CONTROLLER

Corrections

28 JULY 2004

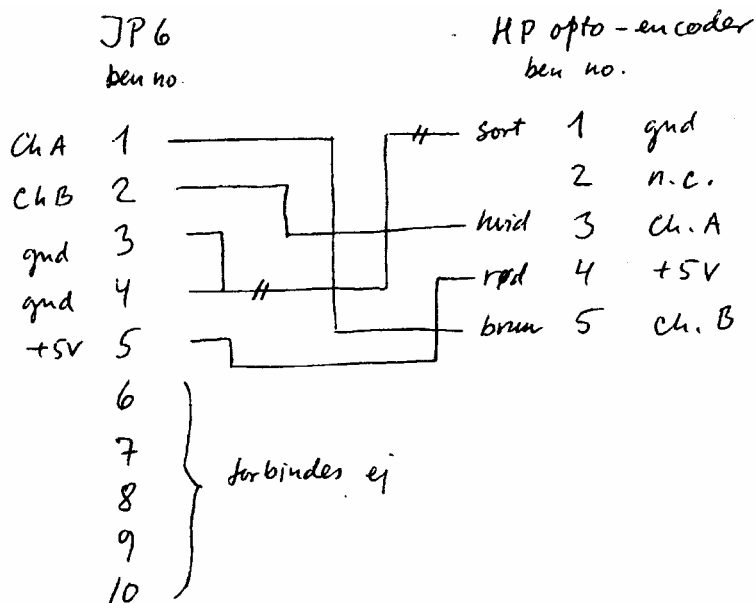
- 1 Read the original Controller Assembly Notes before you start soldering
- 2 Be careful of the orientation of the FETs. For Q1-Q4 (the VP0300L) the devices are oriented as per the layout (flat towards R4 with the centre gate pin bent towards the flat) Q9 and Q10 are **shown WRONGLY** - the flat should be towards the JP4 edge of the board with the centre gate pin bend away from the flat side – check that carefully!
- 3 Check that the orientation of R3, R4, R13 and R14 is correct. Pin 1 is shown wrongly on the board.
- 4 If you use the display LM6733 R12 will not be used and pin 3, 17, 19 and 20 on the display should not be connected. Pin 18 should according to OZ9FW be grounded to remove noise. You may even ground the thick track that goes around the display directly to chassis. Find a short way.

Connections between JP6 and the Opto encoder.

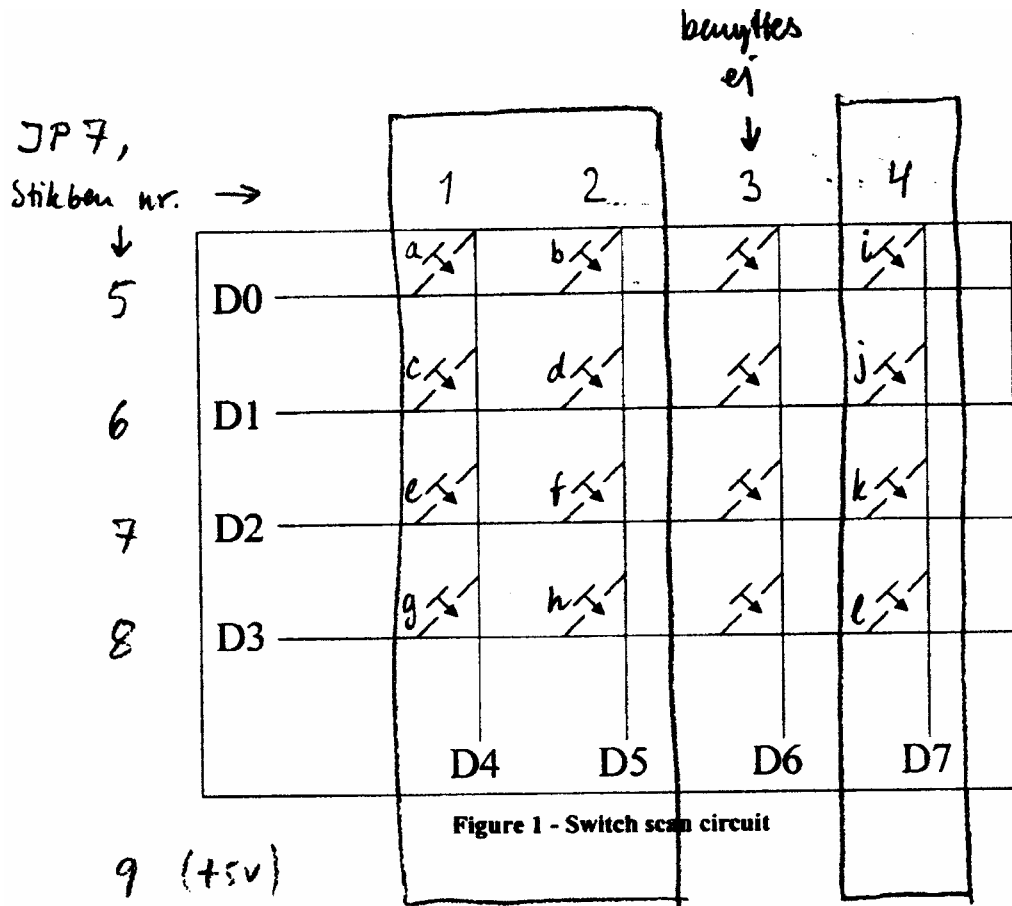
NB kanal A og B skal krydles som vist for at få rotationsretningen til at følge normal omdrejningsretning.

OZ9MO has clarified the connections of the switches and how he has placed them
